SPECIAL USE PERMIT-A FOR NEWBURY AIS, 904 HOMESTEAD ROAD

November 19, 2024

TOWN OF CARRBORO • NC

Preliminary Subdivision Plan

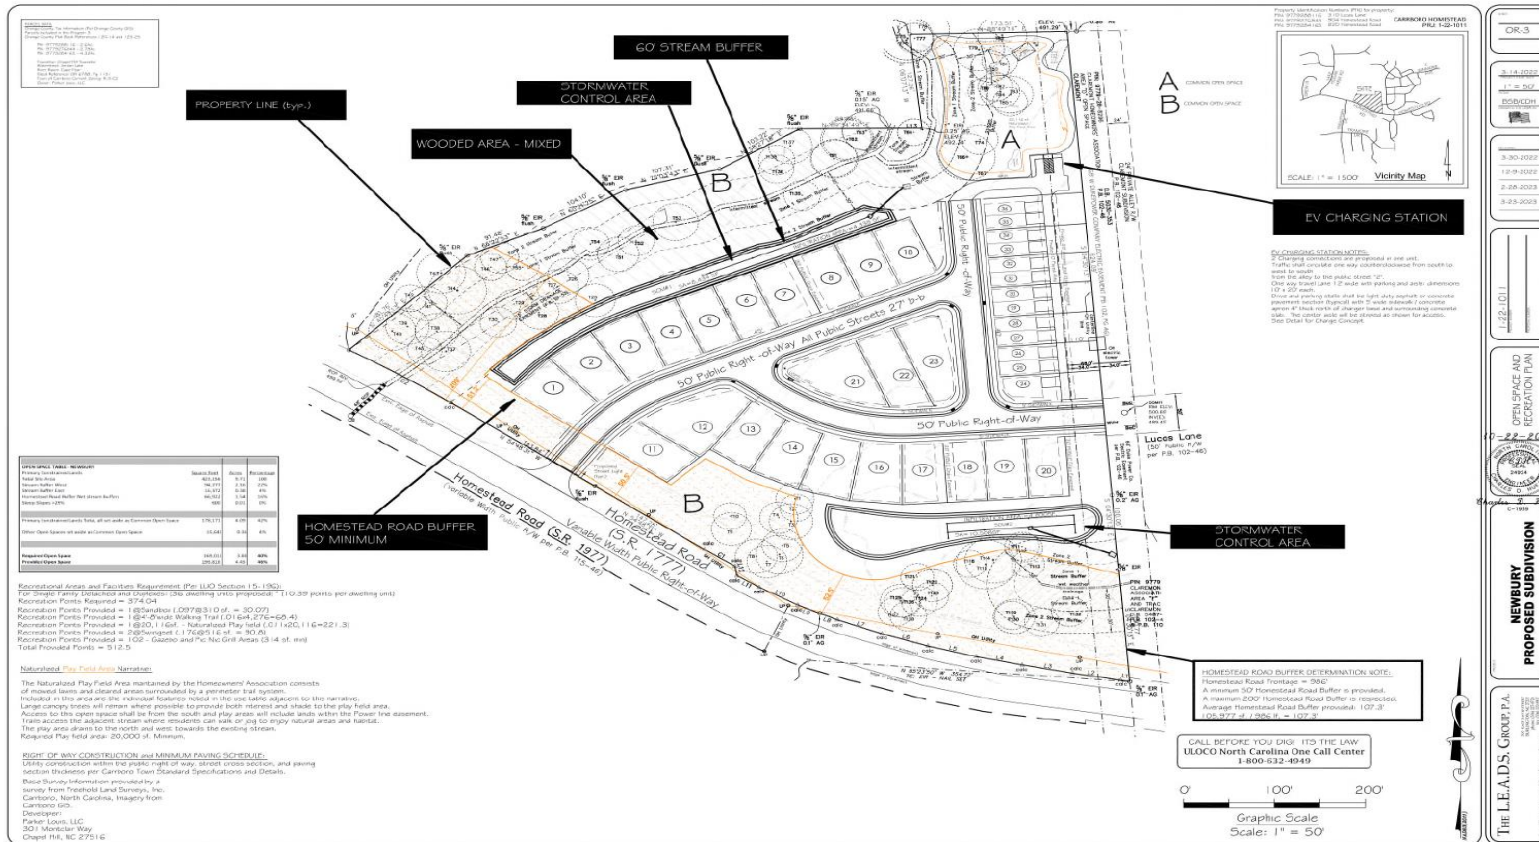
Staff	3. That Town Council finds the use of roll type curb acceptable within the subdivision. The detail drawing for such must be included in the construction plans, and Public Works shall review and approve the final design prior to approval of the construction plans.
Staff	4. That the applicant must receive a driveway permit from NCDOT prior to construction plan approval.
Staff	5. That the construction plans must include a connection to the existing sidewalk in the Claremont subdivision along Homestead Road.

Staff	6. That all street trees planted in accordance with the requirements of LUO Section 15-316 must be located within the public right of way.
Staff	7. That the applicant shall provide to the Zoning Division, prior to the approval of a final plat for the project or before the release of a bond if some features are not yet in place at the time of the recording of the final plat, Mylar and digital as-builts for the stormwater features of the project. Digital as-builts shall be in PDF format and shall include a base map of the whole project and all separate plan sheets. As-built PDF files shall include all layers or tables containing storm drainage features. Storm drainage features will be clearly delineated in a data table. The data will be tied to horizontal controls.

Grading and Stormwater Plan

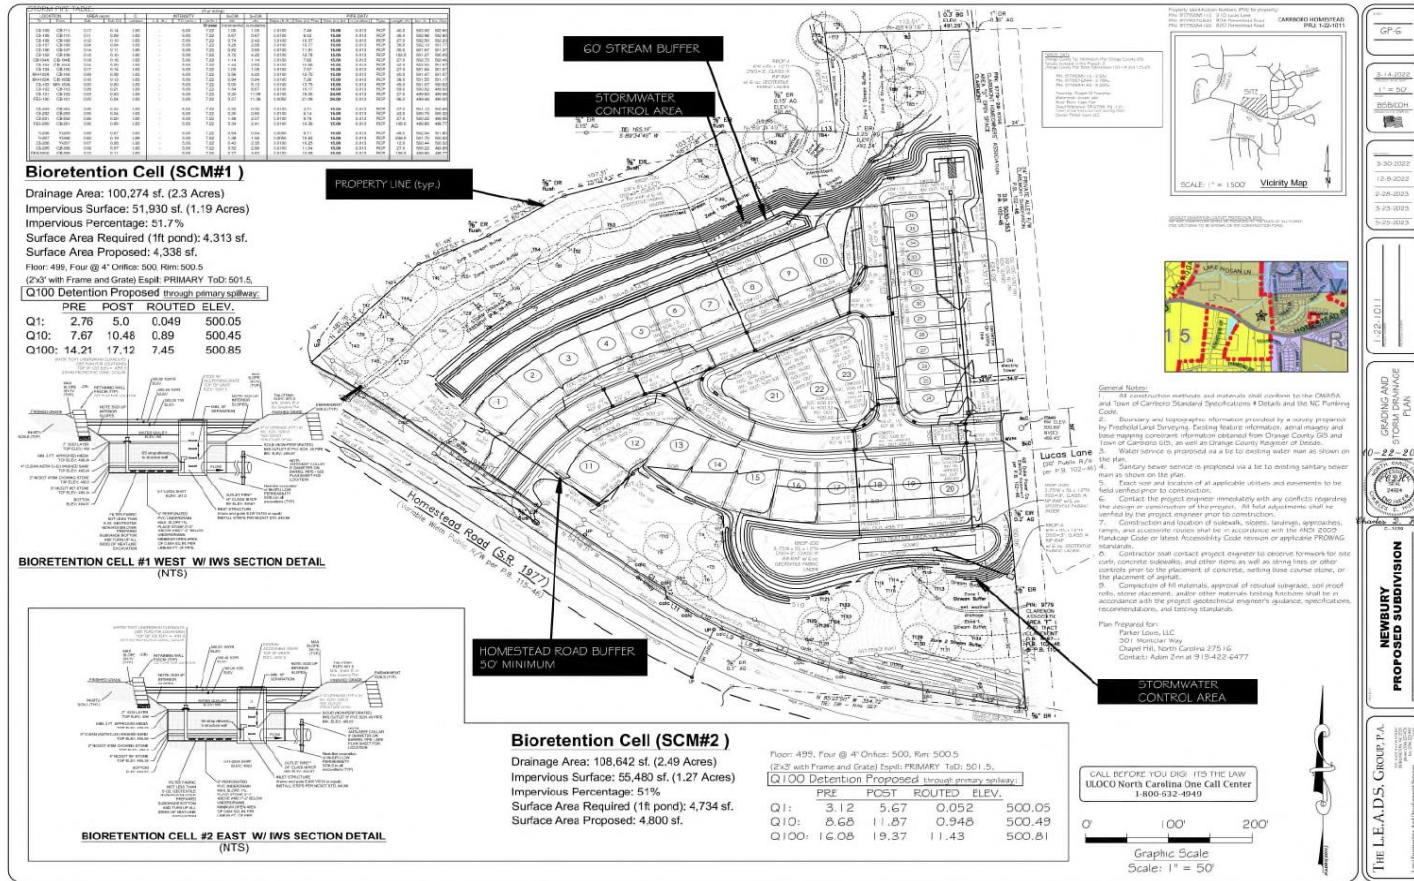
Staff	8. Per Section 15-263.1, that the developer shall include a detailed stormwater system maintenance plan, specifying responsible entity and schedule. The plan shall include scheduled maintenance activities for each stormwater BMP in the development, performance evaluation protocol, and frequency of self-reporting requirements (including a proposed self-reporting form) on maintenance and performance. The plan and supporting documentation shall be submitted to Town engineer and Stormwater Utility staff for approval prior to construction plan approval.
Staff	9. That, prior to issuance of a CO, a final plat, or the certification of a stormwater BMP, the applicant shall submit a performance security to be posted and held by the Town for a period of two years per the provisions of Section 15-263(i).

Staff	10. That the developer shall follow all established town procedures associated with the installation of SCMs within the development, including but not limited to filing Operation and Maintenance Agreements and submitting and receiving approval of as-built drawings for all SCMs, in accordance with established town procedures in place at the time. The developer must also make clear to both the town staff and the HOA representatives in place at such time exactly when any related responsibilities have transitioned to the HOA.
Staff	11. That the developer must submit the final version of the project's design to the electric utility and must provide another written statement from such electrical utility stating that electric service can still be provided to all locations shown on the construction plans prior to the approval of the construction plans.

Stormwater Advisory Commission	4. We continue to recommend consideration of permeable surfaces for parking (see individual parking units at Shelton Station).
Stormwater Advisory Commission	5. We continue to recommend that the developer keep disturbed areas including SCMs and all platted lots out of stream buffers.
Stormwater Advisory Commission	6. SWAC appreciates that the applicant has reconsidered plans to remove trees in order to create an open playfield. We appreciate the addition of a naturalized play area with large canopy trees and a walking trail to the concept plan.
Stormwater Advisory Commission	7. We recommend that the developer minimize tree removal to the extent possible.
Stormwater Advisory Commission	8. Please refer to the chart provided in the individual SWAC recommendation statement for additional information relating to their analysis of alignment and compliance with the <i>Carrboro Connects</i> comprehensive plan
